SERVICE INFORMATION LETTER NO. 0187

1. SUBJECT: Universal Block, P/N 28-14117-11
2. MODEL: F-28A, F-28C, F-28F, 280, 280C, 280F, and 280FX
3. EFFECTIVITY: All S/N having received or are scheduled for T-T strap modification via STC SR03465CH; Excludes F-28F S/N 832 and subsequent and 280FX S/N 2147 and subsequent.
4. BACKGROUND:

Figure 1. Universal Block Inspection (top); Rework Criteria (top and bottom)

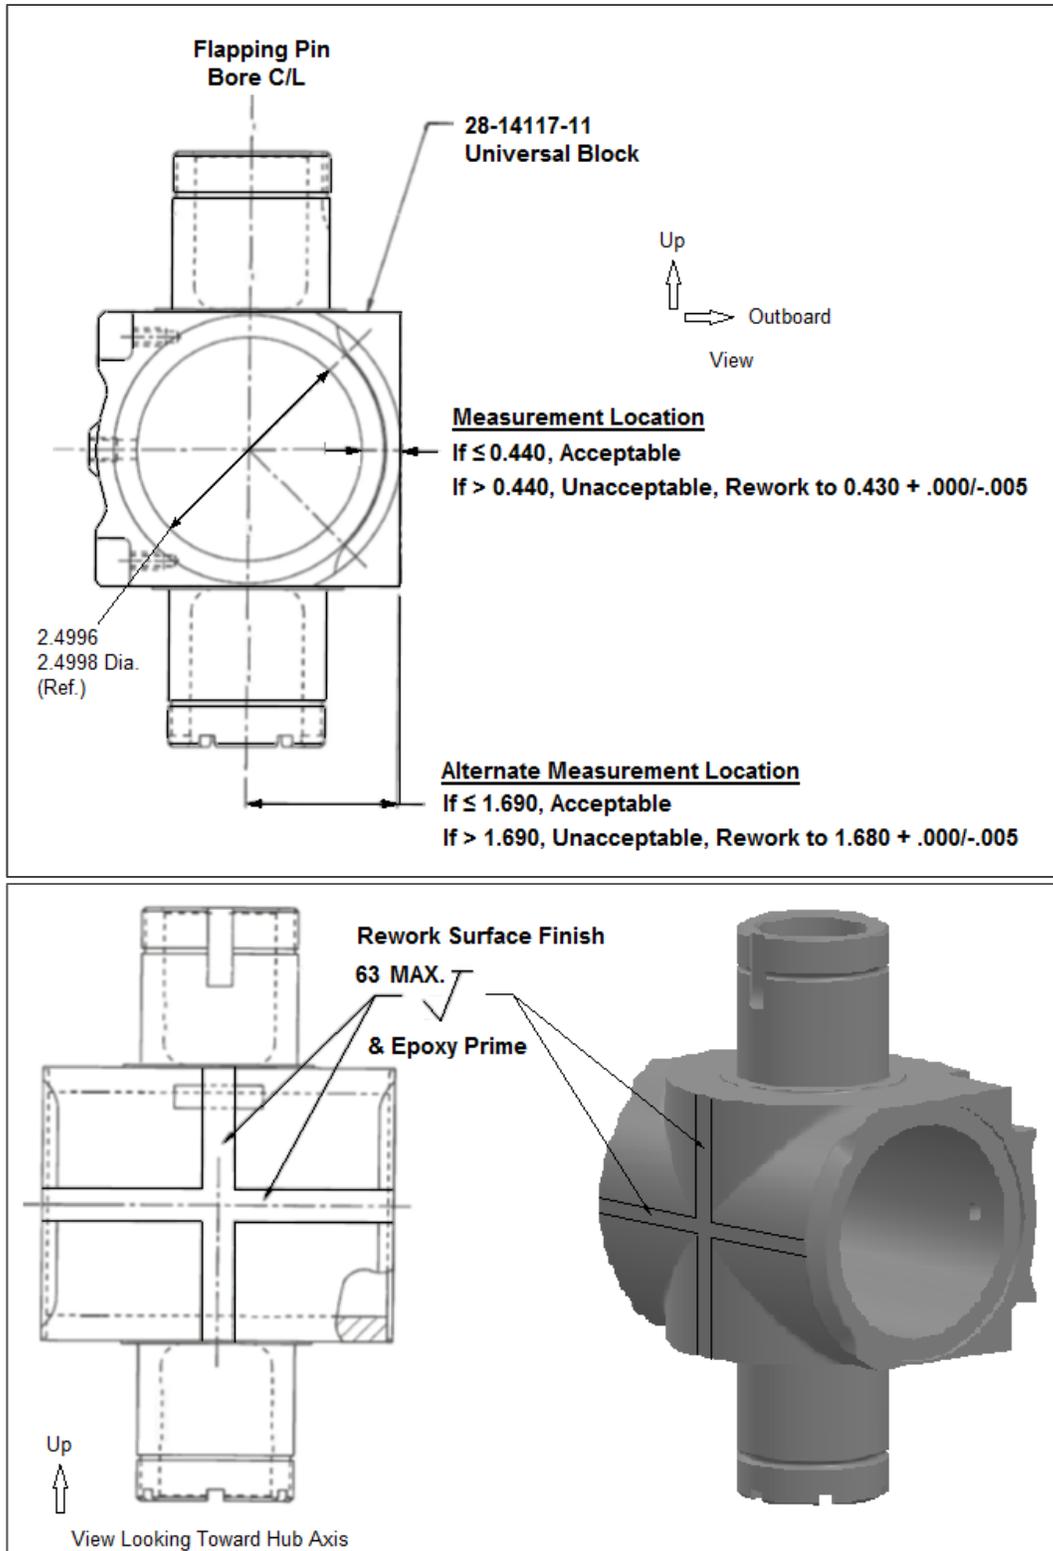
This Service Information Letter (SIL) provides information for inspection and rework, if required, of the universal block (U-block) (P/N 28-14117-11) of the main rotor hub assembly to allow clearance between the universal block and the retention assembly (P/N 28-14234-9). In some cases, the P/N 28-14234-9 retention assembly may contact the P/N 28-14117-11 U-block. If there is contact after conversion to P/N AA-ECD-084-280 T-T straps, the U-blocks should be reworked in accordance with this SIL. Reworking per this SIL, either before or during conversion, should prevent contact.

6.2.1 Measure the cross-section distance from the flapping pin bore surface to the outside surface of the universal block (Figure 1). (An alternate measurement location, flapping pin bore centerline to outside surface, is also acceptable for determining if rework is necessary. See Figure 1.)

6.2.2 If the width is less than or equal to 0.440, no further action is required.

6.3 If the width is greater than 0.440, the universal block surface must be reworked to yield a width of $0.430 + .000/-0.005$ (Figure 1).

6.3.1 Rework the surface (63 maximum surface finish) (Figure 1).

6.3.2 Epoxy prime the reworked surface. (Epoxy primer may be procured from a local source.)
